PCN NUMBER	PCN002
DATE	26/07/16
AFFECTED P/N	QAM-TX2-433

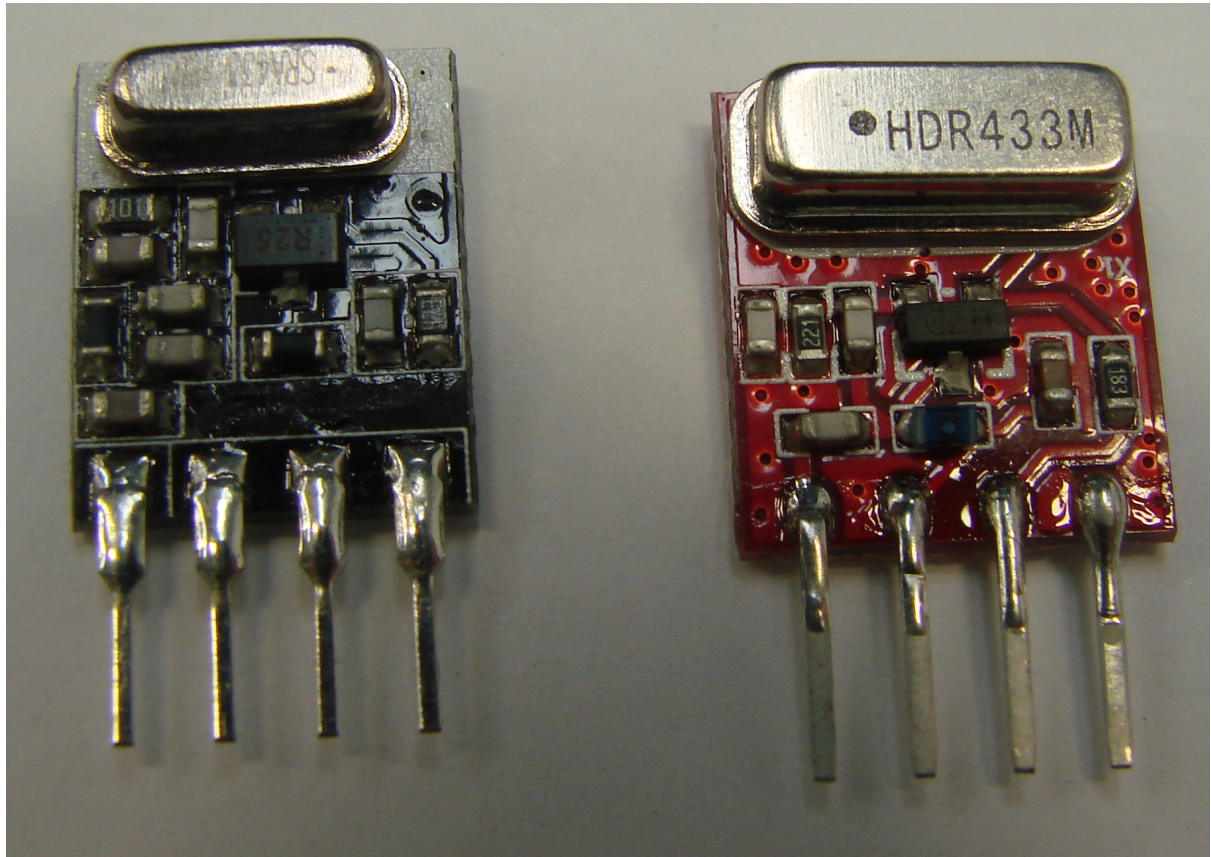
<p>CHANGE NOTIFICATION</p>	<ul style="list-style-type: none"> • Product Size: <i>OLD:</i> Width = 10.70mm / Height = 18.55mm <i>NEW:</i> Width = 11.75mm / Height = 18.80mm • Layout: The component layout has changed. See the image on page 2. This is the new approved design. • Components: <ol style="list-style-type: none"> 1. PIN: A new pin type is being used. This is suitable for the product application. However, the new dimensions are as follows: <i>OLD:</i> 0.25mm x 0.50mm <i>NEW:</i> 0.27mm x 0.70mm 2. XTAL: A new crystal is aesthetically bigger but has the same functionality. 3. PCB: This is now red. 4. SMT: components have the same characteristics but may visually vary.
<p>TRACEABILITY</p>	<p>Maintained through internal RFS supplier records.</p>
<p>STOCK ACTION</p>	<p>To be kept separate on the shelves. Once the old stock is used up, please move over to using the new stock.</p>
<p>INSTALLED PRODUCT ACTION</p>	<p>No action required. This product will function as intended.</p>
